DESIGN REVIEW BOARD – URBAN DESIGN PANEL

AGENDA - Amended 5/5/2021

May 6, 2021

**Planning Staff Report to
Design Review Board - Urban
April 30, 2021**
for the May 6, 2021 Public Hearing

GRADING PLAN L-002

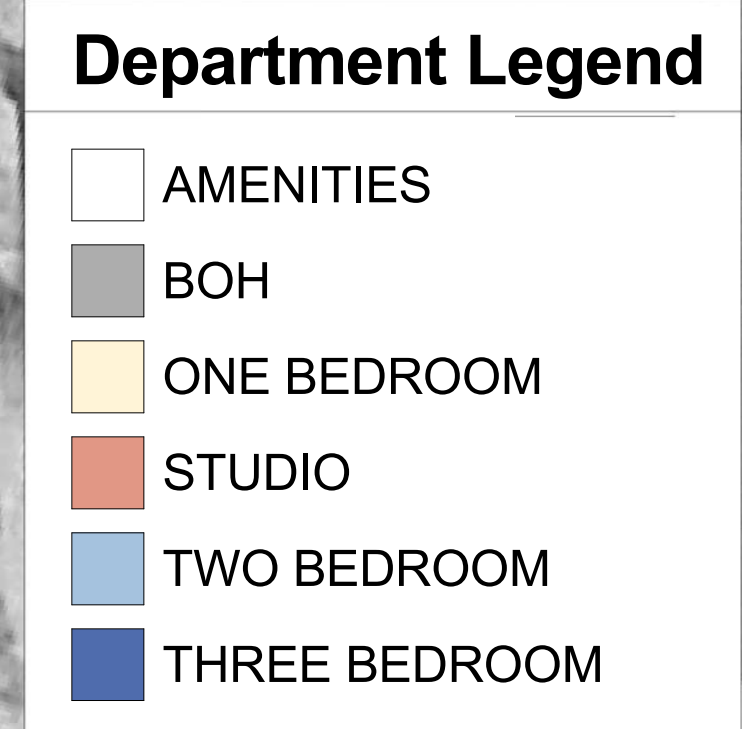
- **PUB 5.1:** The proposed landscape plan does not appear complete or well-conceived, even as a schematic level design. Primary access points show landscape and bushes in front of doors that are not provided access to any exit surface such as a sidewalk (Landscape Plan, Sheet L-001).
